GRINNELL COLLEGE
FORUM ADA EVALUATION

February 11, 2011

non-compliance evaluation

NON-COMPLIANCE EVALUATION – EXISTING LOWER LEVEL PLAN

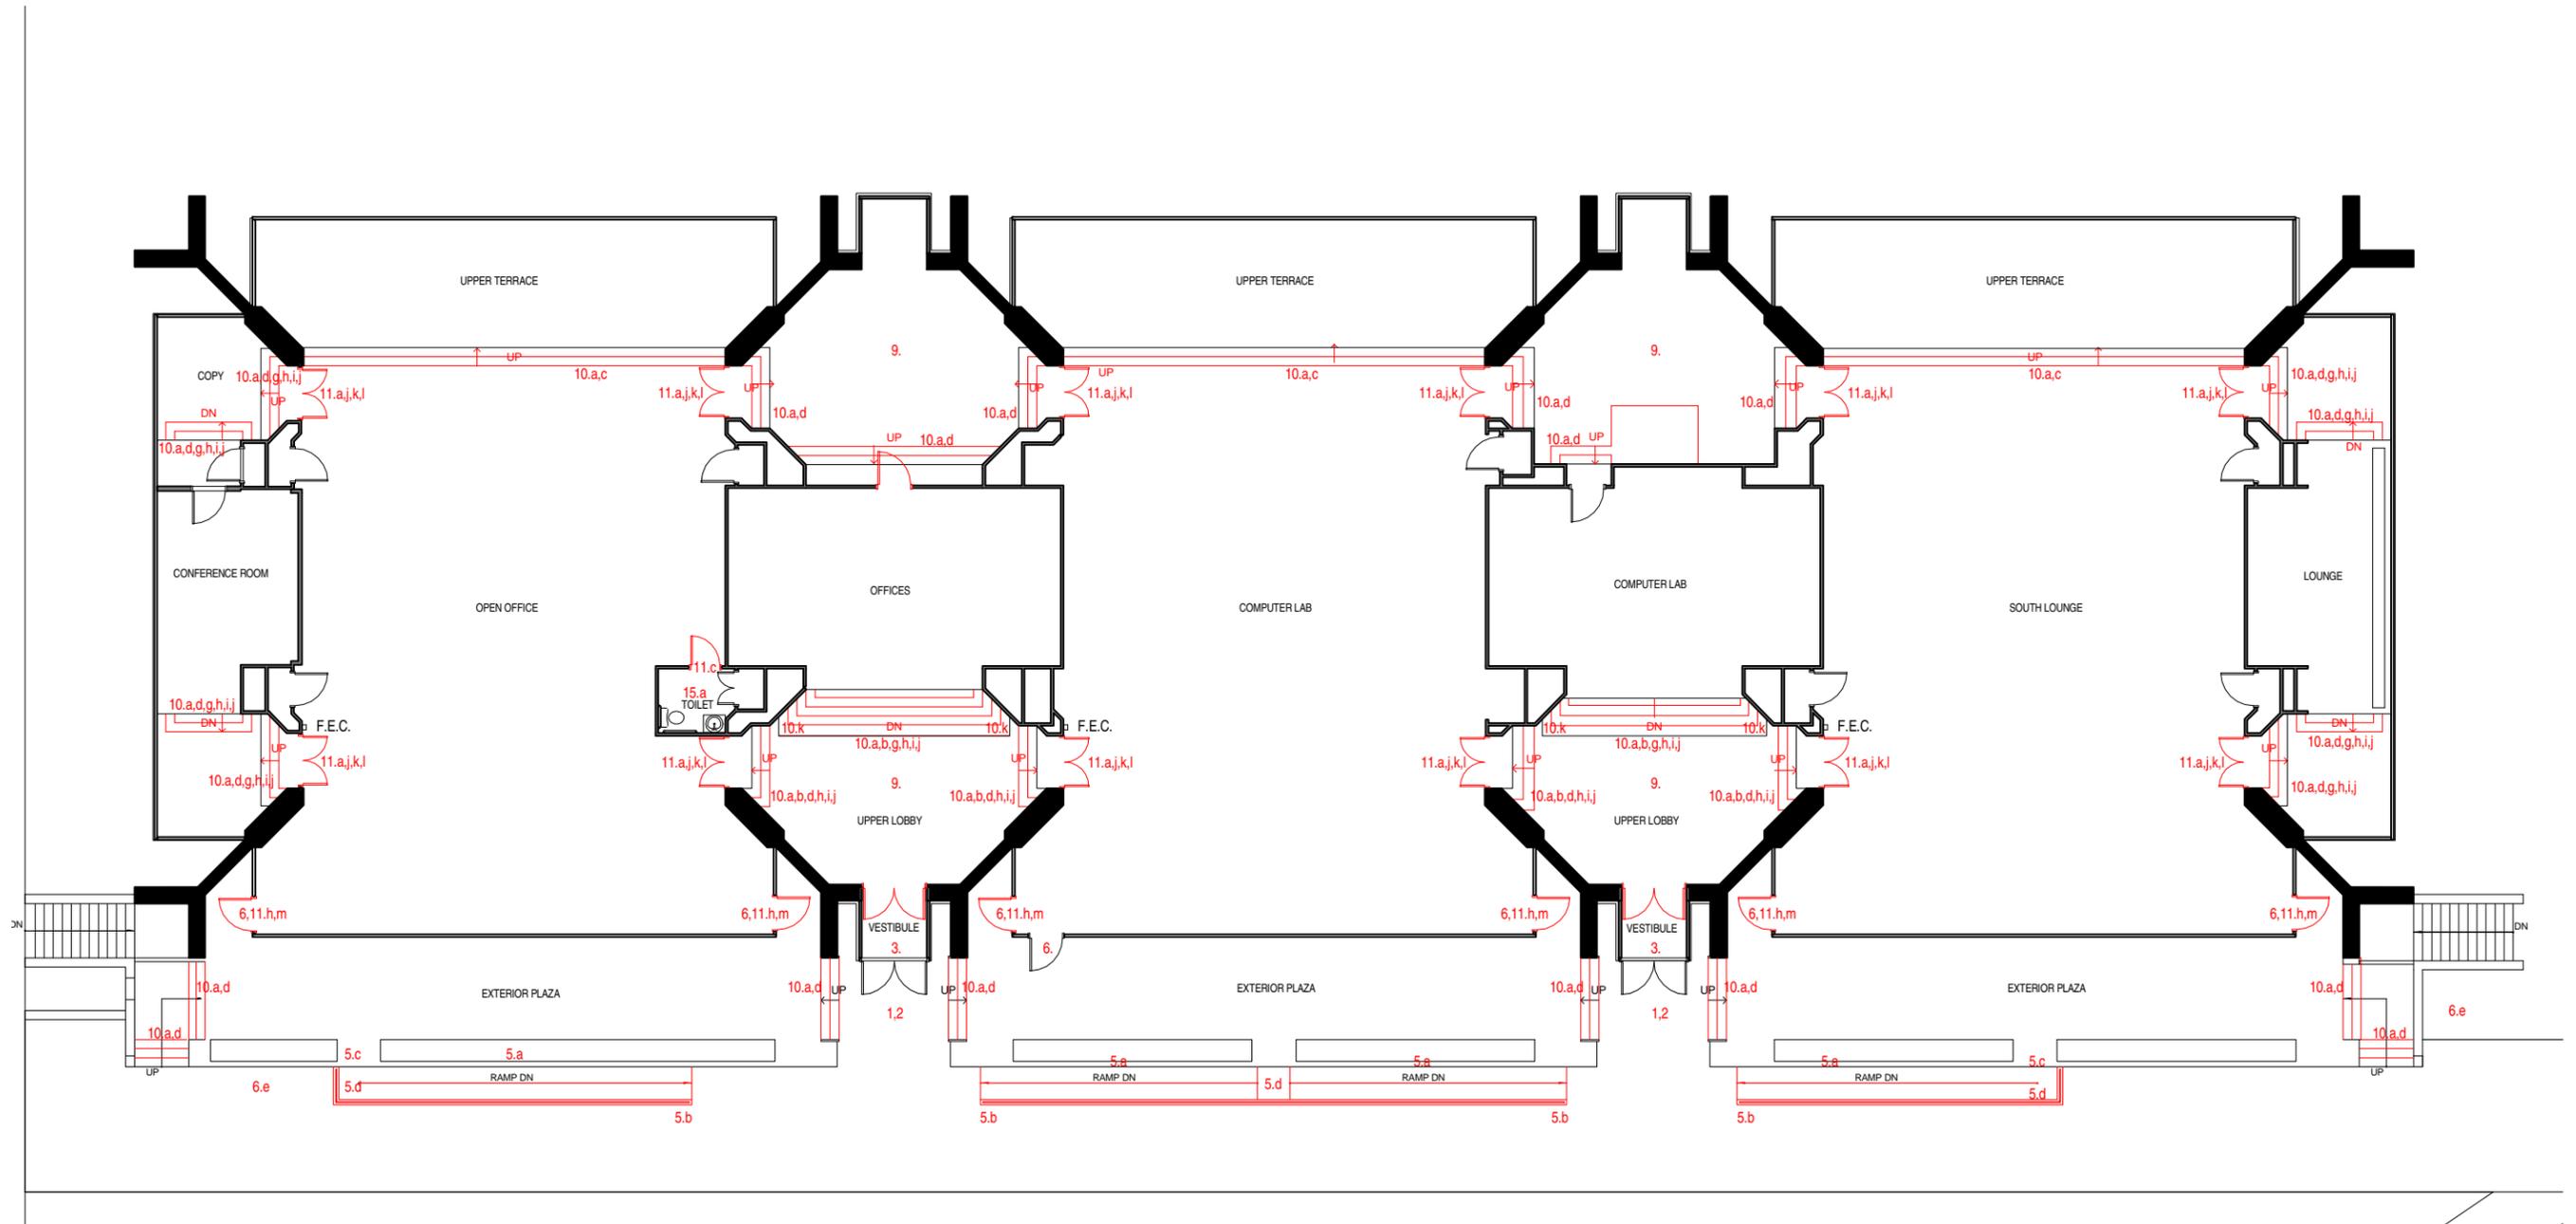
1. The building does not comply with the requirements to have 60% of all public entrances to be accessible.
ADAAG: 2010 206

2. The building also does not comply with the requirements to have at least one accessible entrance to each tenant space of a building.
ADAAG: 2010 206

3. Vestibule Entrances – Lower Level Northeast & Upper Level, Main West Entries:
 - a. Require a 7' minimum distance between the vestibule doors.
ADAAG: 1998 4.13 & 2010 404

5. West Ramps: These ramps are non-compliant.
 - a. Handrails are required on both sides of these ramps.
ADAAG: 1998 4.8 & 2010 405, 505
 - b. Handrails do not have the 12" minimum extension at the bottom of the ramps.
ADAAG: 4.8 & 2010 505
 - c. It was observed that the north and south ramps have a 1" and 2" vertical transition from the top of the ramp landing to the terrace levels. No transition is allowed at these locations.
ADAAG: 1998 4.5 & 2010 303
 - d. The top landings are also to be 60" long. The current landings vary from 36" to 48" in length.
ADAAG: 1998 4.8 & 2010 405
 - e. It is also noted that location over 30" in height require guardrails that will not allow a 4" sphere to pass per building code.

6. Terrace West Entries: The original doors do not provide adequate clearance to function as accessible entrances. Side approach to pull doors with closures require 54" clear perpendicular to the door.
ADAAG: 1998 4.13 & 2010 404

7. Lower Level (Horizontal): The only accessible entrance for the building is the South East Entrance. This limits the building accessibility to the South 1/3 of this level. The corridor between the two lobbies does not have adequate push/pull clearances, which cuts off accessibility to the rest of the building.
 - a. Accessible routes should connect all accessible building entrances to all accessible spaces and features within the building.
ADAAG: 1998 4.1, 4.3 & 2010 206
 - b. Accessible routes for all occupant work areas.
ADAAG: 1998 4.1 & 2010 203

9. Corridors (Lower Level)
 - a. Corridors to provide wheelchair turn around spaces for minimum of a 60" diameter.
ADAAG: 1998 4.2 & 2010 304

- a. The stair treads throughout the whole building are less than the required 11" depth. The riser height vary 3/8", which is acceptable per building code.
ADAAG: 1998 4.9 & 2010 504

- b. The black 6" wide stair tread nosings do not provide enough visual contrast to the individual steps which create dangerous conditions. (See appendix for pictures). It is recommended that the tread nosing be a depth of 1 to 2 inches. The leading edge of treads should contrast in color with the rest of the treads to increase visibility.
ADAAG: 2010 504

- j. The top of the handrails shall be at a constant height of 34" to 38" from the top of the tread nosing. Existing heights between 25" to 32" were observed.
ADAAG: 1998 4.9 & 2010 505

14. Obstructions:
- a. 80" is required for clearance heights. Existing duct work in corridors was noted at 75" above the floor.
ADAAG: 1998 404 & 2010 307

NON-COMPLIANCE EVALUATION – EXISTING UPPER LEVEL PLAN

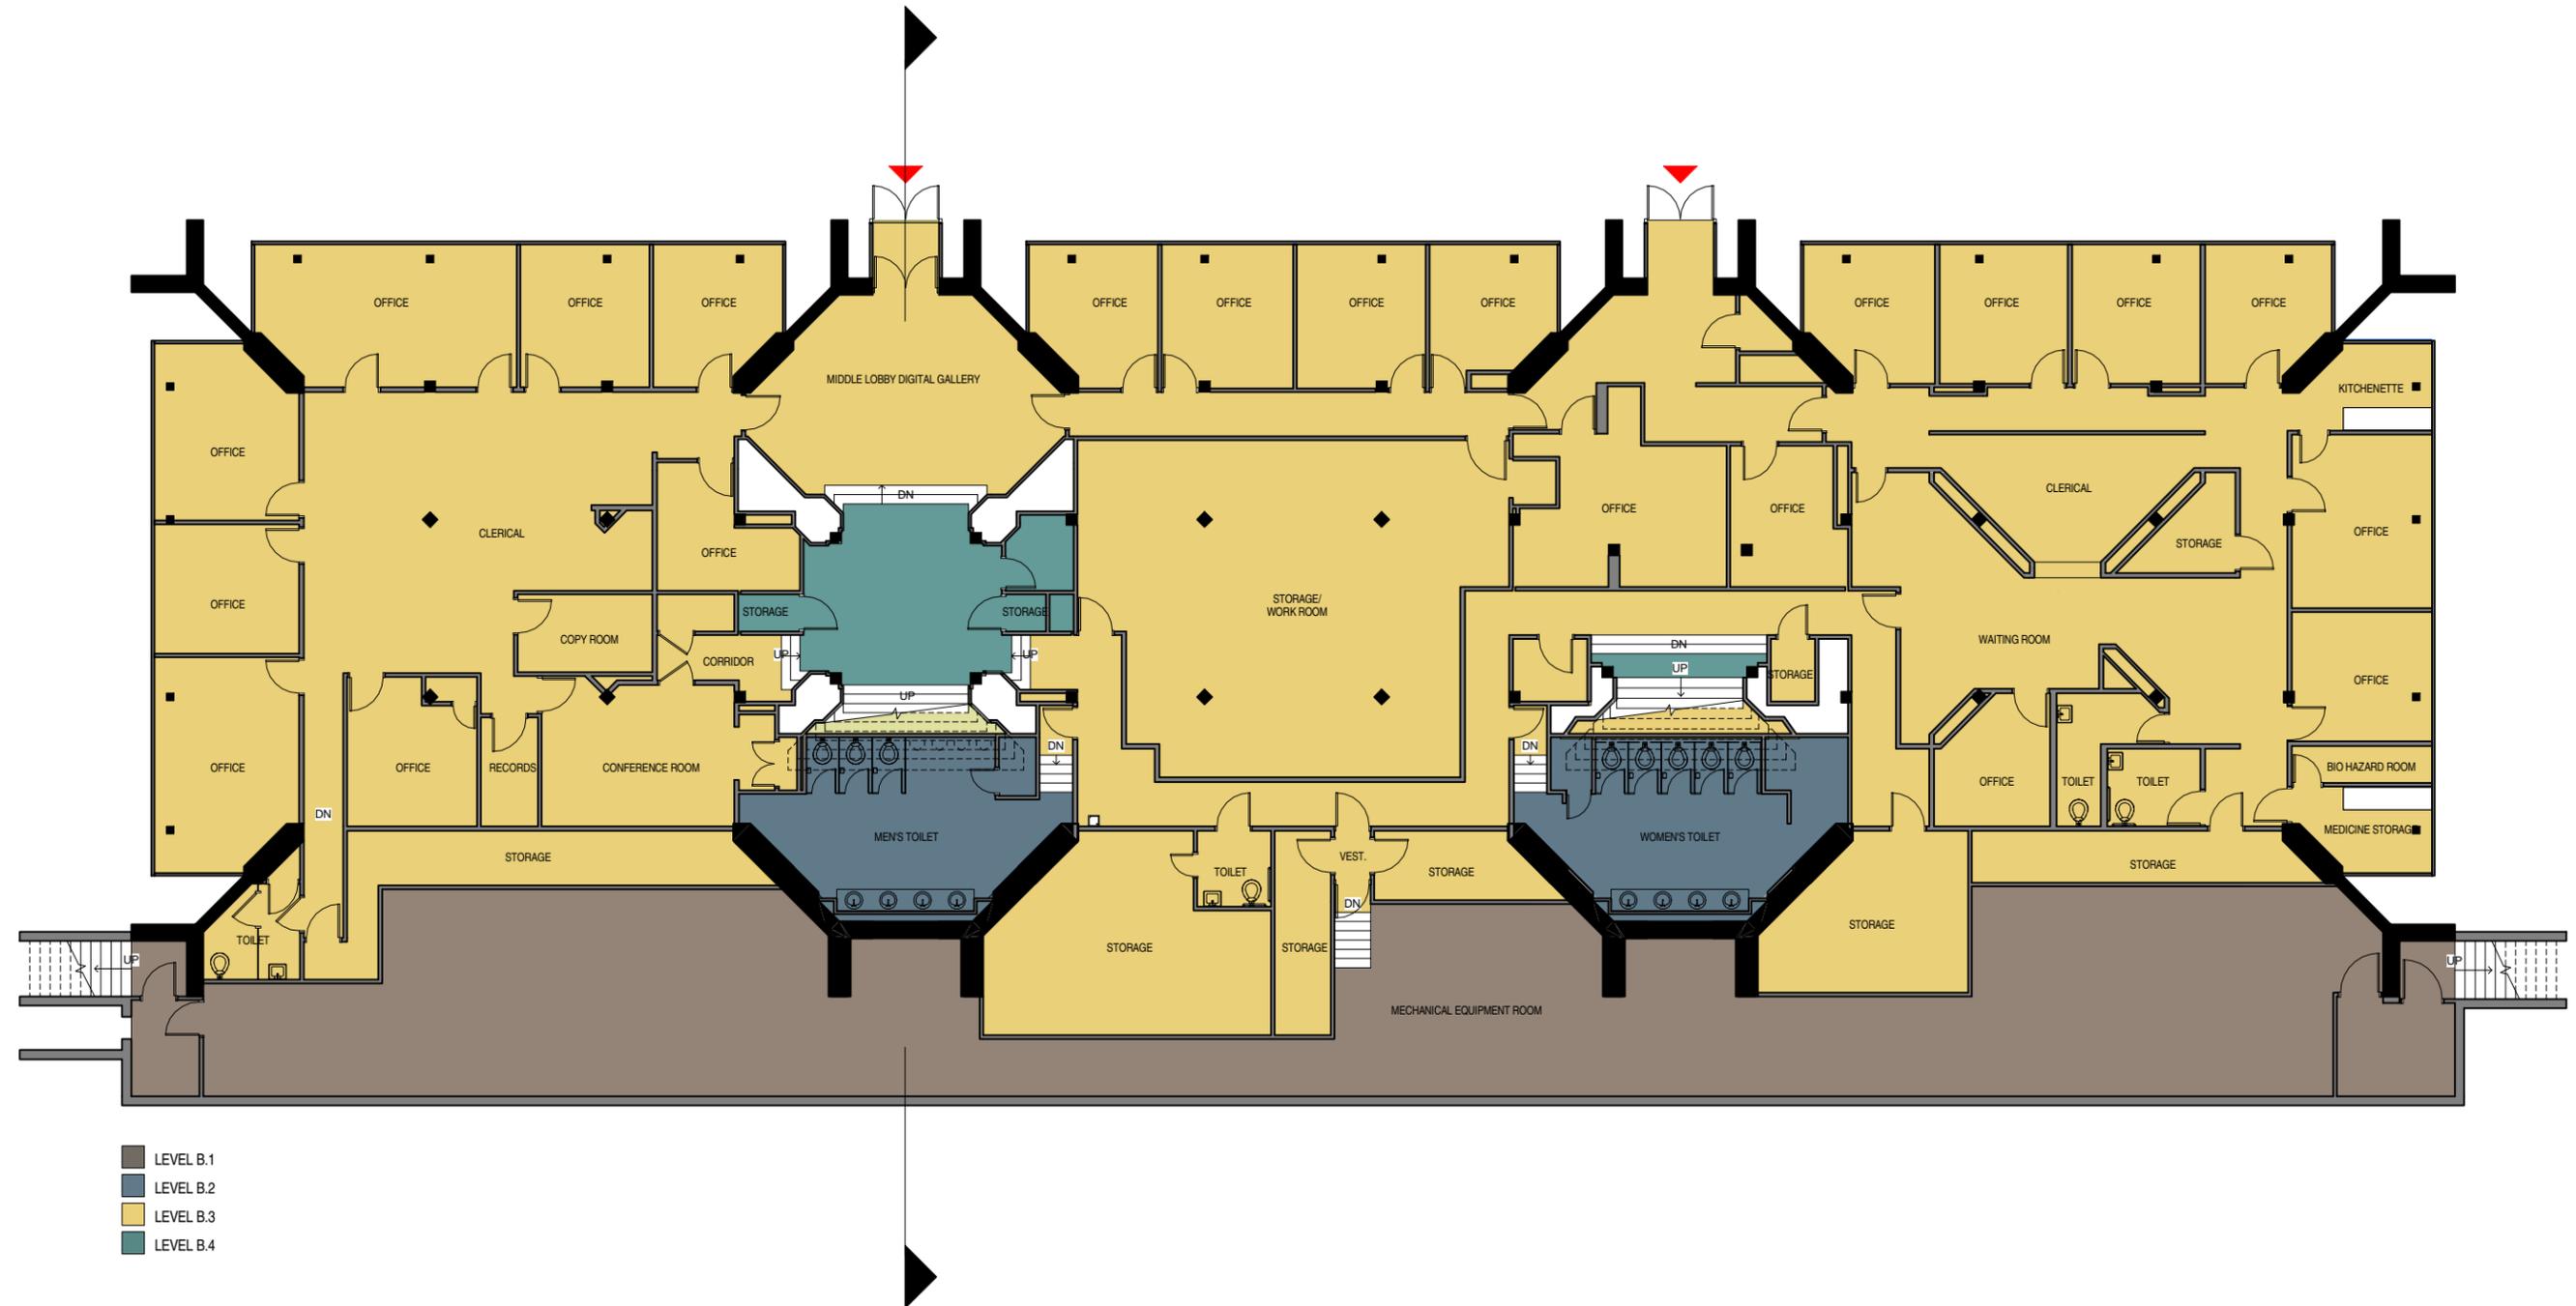
The new door that was added is not accessible as an entry door as the ramps to it are non-compliant.

8. Upper Level (Horizontal)
None of the entries on this level are truly accessible, due to the limited size of the vestibule & the multiple stairs just inside the Lobby. Which means that there is no accessible route to any of the functions on this level.

15. Priority 3 – Toilets...
- a. Upper Level – North Lounge Toilet
 - i. Entrance door is not compliant. Door swing can be altered to allow pull clearance.

- ii. The door knob and lock are not compliant for accessible grasping.
 - iii. Signage with Braille is too close to the side wall and the door access. Signage can be relocated to other side of door to comply.

- iiii. The toilet and the sink are too close to the side walls, spacing should be 16" to 18" from the center line.
 - v. The side grab bar beside the toilet is 36" long, 42" is required.
